ADDENDUM No. 1

REQUEST FOR QUOTATION No.: 1220-040-2023-069

TITLE: BEECHER PLACE PUBLIC WASHROOM
RENOVATION

ADDENDUM ISSUE DATE: NOVEMBER 28, 2023

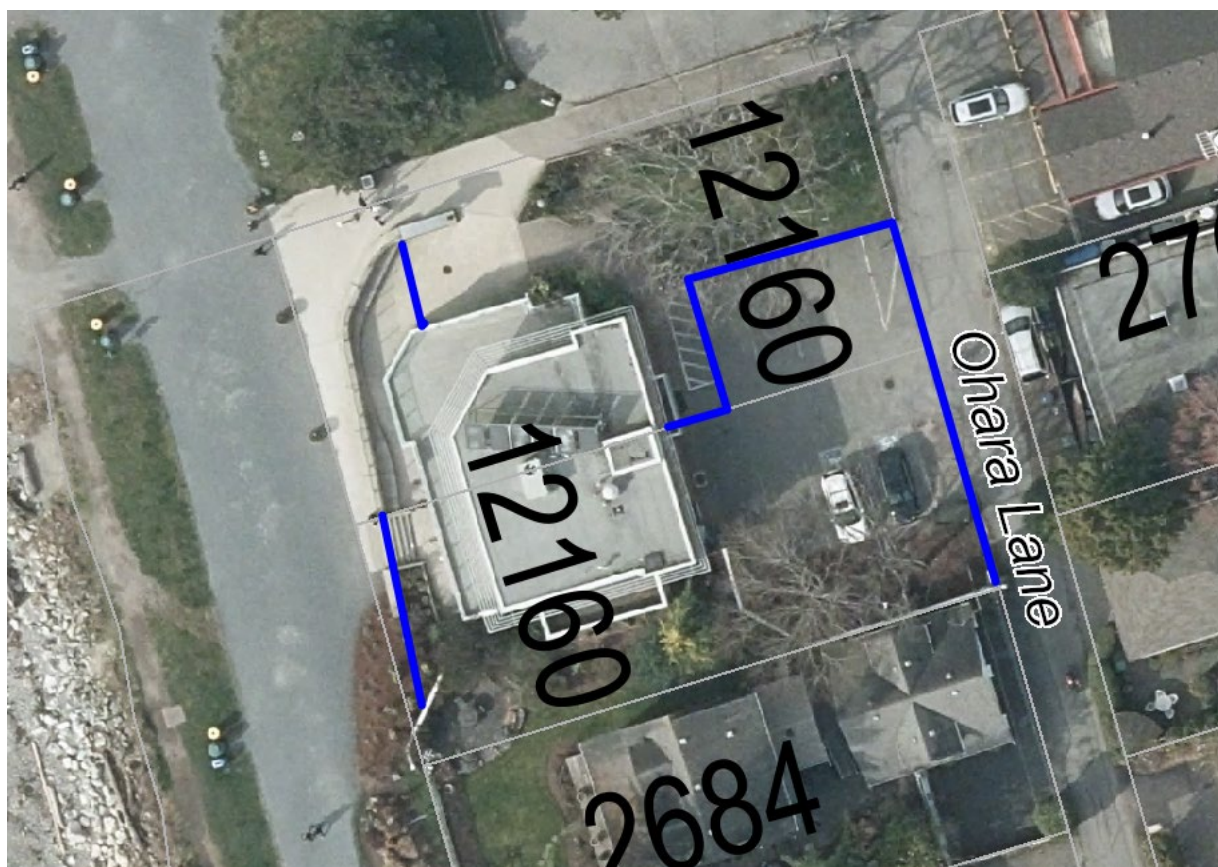
- Q8. They have a stainless steel urinal and a porcelain urinal in the fixture specs. Which would they prefer?
- A8. Porcelain toilets and urinals.
- Q9. The plumbing fixture list notes a lever handle faucet for the sinks but there was mention of a hands-free faucet. Can we get clarification on which we should be pricing out?
- A9. Refer to Schedule B – Appendix 2 – Supplementary Specifications: hands-free.
- Q10. It was discussed during the site walkthrough that a hazmat report / hazard condition assessment would be issued in an addendum. Please advise.
- A10. See file Pre-Project Hazmat Survey Report on the City's MFT site. Page 44 of the RFQ document has instructions on how to access the City's MFT site.
- Q11. It was discussed during the site walkthrough that a hoarding plan would be issued in an addendum.
- A11. See below:
